# City of San Antonio

Re: **Interpark**

**MDP # 002-08**

**INTERPARK  
MASTER DEVELOPMENT PLAN (MDP)**

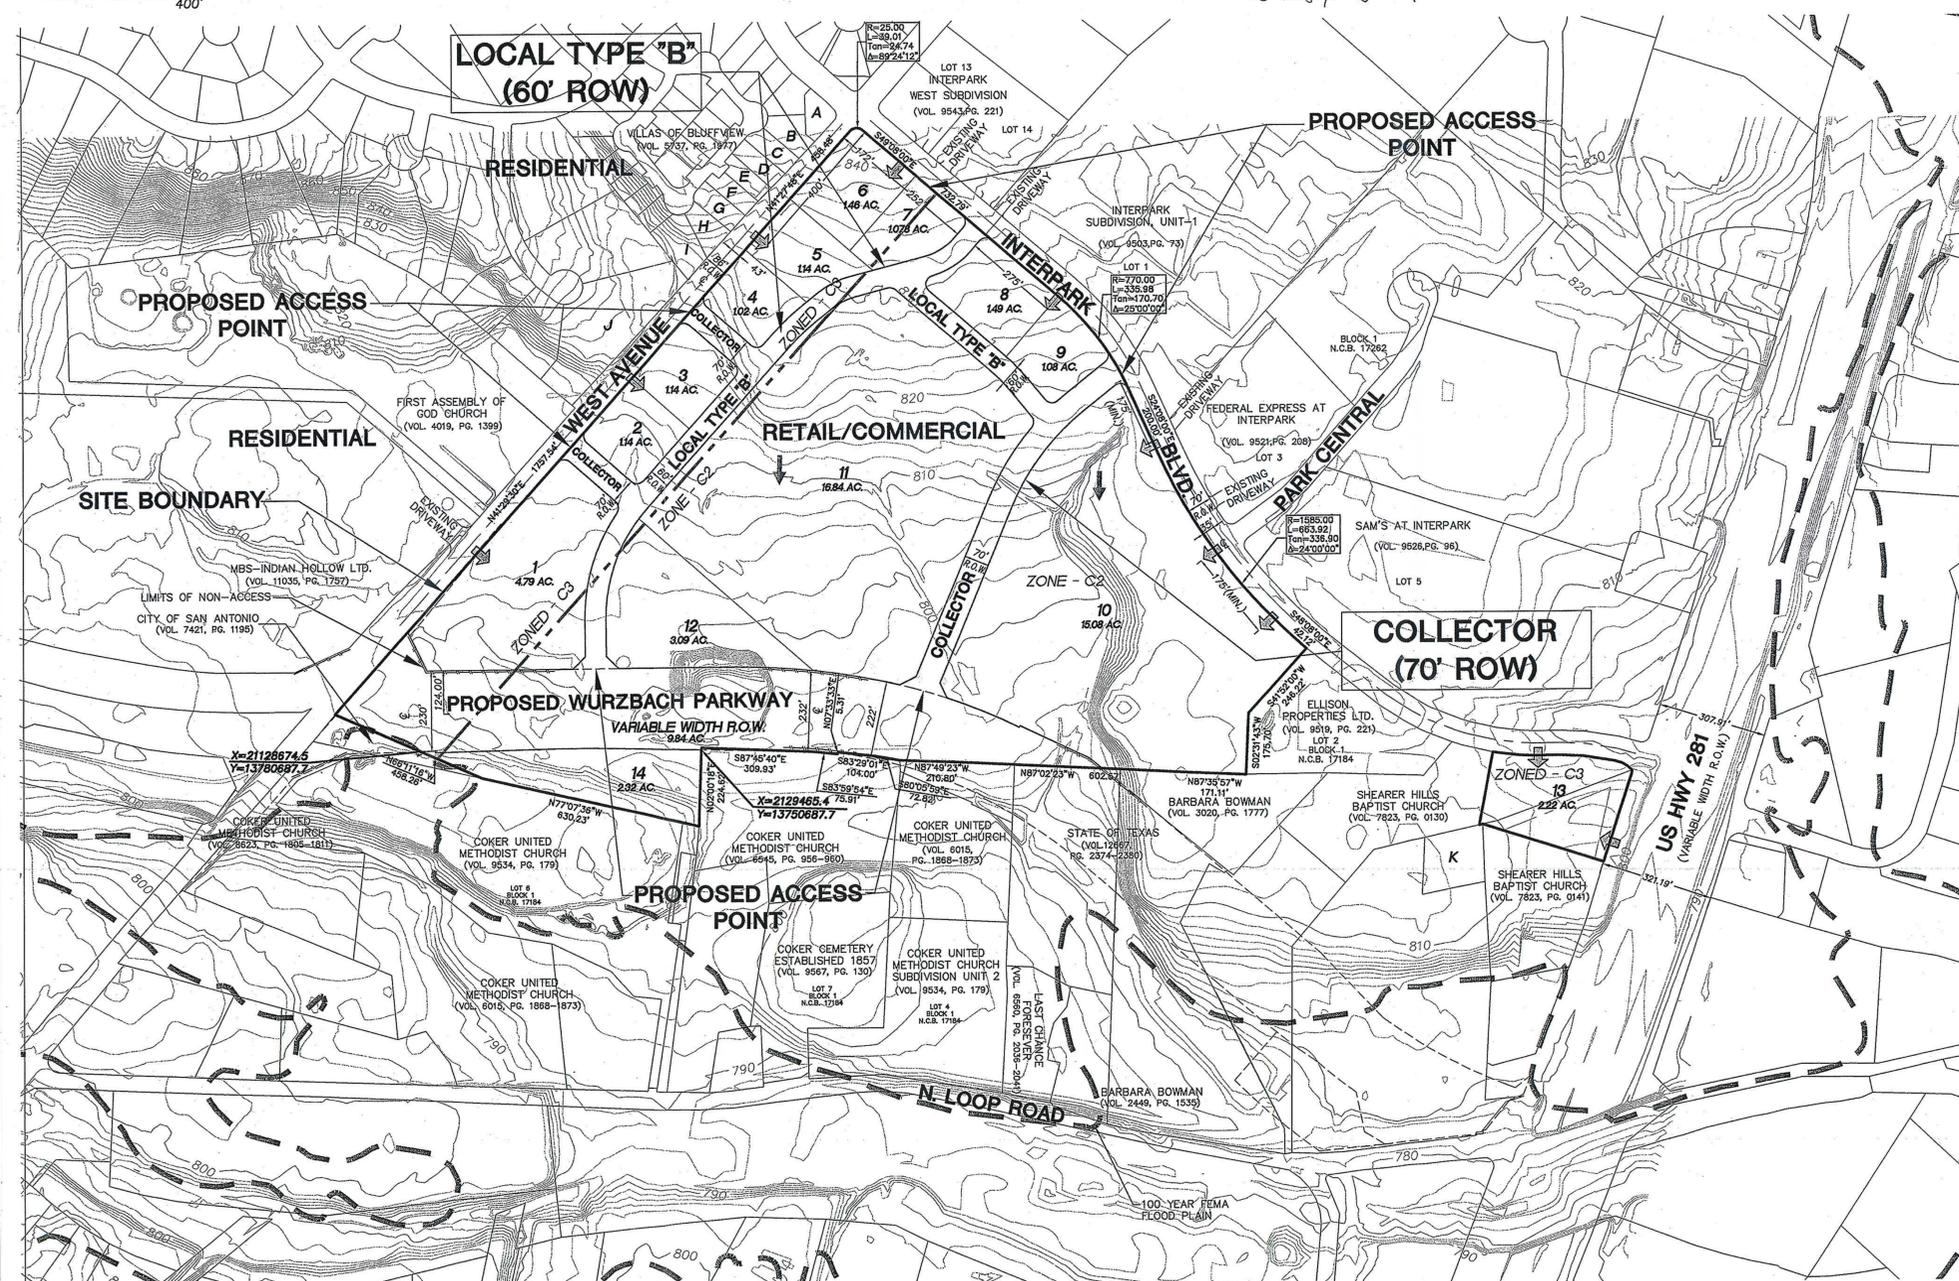
Place sidewalks along property lines instead of curb-line for proper alignment with perpendicular curb-ramps and crosswalks.

R303.2.1 Perpendicular Curb Ramps. Perpendicular curb ramps shall have a running slope that cuts through or is built up to the curb at right angles or meets the gutter grade break at right angles.

- West Avenue and Driveway A Intersection – Northbound right turn lane is required for the intersection of West Avenue and Driveway A. A minimum of 270 feet (including 120 feet of taper and 150 feet of storage) shall be provided based on the 45 miles per hour posted speed on West Avenue.

- Interpark Boulevard shall be restriped to provide a center two way left turn lane and one travel lane in each direction.
- Driveways located within 400 feet of the intersection of West Avenue and Interpark Boulevard shall be restricted to right-in/right-out access using appropriate PW standards.

- The City of San Antonio recommends the construction of a northbound right turn lane at the intersection of West Avenue and Interpark Boulevard.
- The westbound approach for the intersection of West Avenue and Interpark Boulevard should include one thru/left-turn lane and one right-turn lane. The traffic signal timing operation for the intersection of West Avenue and Interpark Boulevard should be optimized to improve the LOS operation. Please coordinate with the Public Works Department.

- Driveways A, B, C, and D shall be designed in accordance with the City of San Antonio requirements for Collector roadways. The approaches from these driveways shall include separate left and right turn lanes.

- Driveways E, F, J, K, L, M, and N shall be designed to include one entering and one exiting lane.
- Driveways G, H, and I shall be designed to include one entering and two exiting lanes, one of which is a dedicated right-turn lane.
